# CITY OF ALBUQUERQUE

August 18, 2017

**Re: Oso Bio Syringe Line  
4401 Alexander Blvd. NE  
Traffic Circulation Layout  
Engineer's Stamp 7-31-17 (F16D003B1)**

## TRAFFIC CIRCULATION PLAN

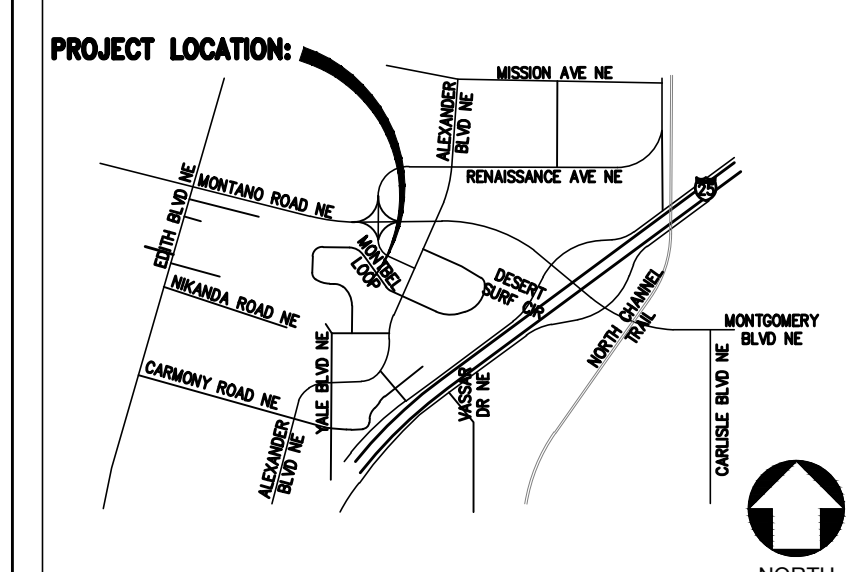
1. Please provide a site plan showing the entire property.
2. ADA accessible parking spaces must be updated to current ADA standards.
  - a. The handicap accessible spaces must be a minimum of 8.5 ft. in width and include an access aisle. Van accessible aisles should be 8ft wide; all others should be 5ft wide.

- b. The ADA accessible parking sign must have the required language per 66-7-352.4C NMSA 1978 **"Violators Are Subject to a Fine and/or Towing."** Please call out detail and location of HC signs.

- c. The ADA access aisles shall have the words **"NO PARKING"** in capital letters, each of which shall be at least one foot high and at least two inches wide, placed at the rear of the parking space so as to be close to where an adjacent vehicle's rear tire would be placed. (66-1-4.1.B NMSA 1978)

- d. Per DPM, a 6 ft. wide ADA accessible pedestrian pathway is required from the HC parking stall access aisles to the building entrances. Please clearly show this pathway and provide details.

- e. ADA accessible pedestrian pathway should not be placed behind parking space or adjacent to a vehicular way. Vehicle and pedestrian/wheel chair conflicts should be avoided as much as possible.

3. Unused curb cuts must be replaced with sidewalk and curb & gutter. A build note must be provided referring to the appropriate City Standard drawing.

4. Identify the distance from the proposed building to the end of the parking aisle island.
5. Per the zoning code, a 6 ft. wide ADA accessible pedestrian pathway is required from the public sidewalk to the building entrances. Please clearly show this pathway and provide details.

6. ADA curb ramps on frontage of property must meet current ADA requirements and should have detectable warning surface/ truncated domes that meet current ADA standard.
7. Sidewalk will be required on frontage of property. All sidewalks along streets should be placed at the property line.
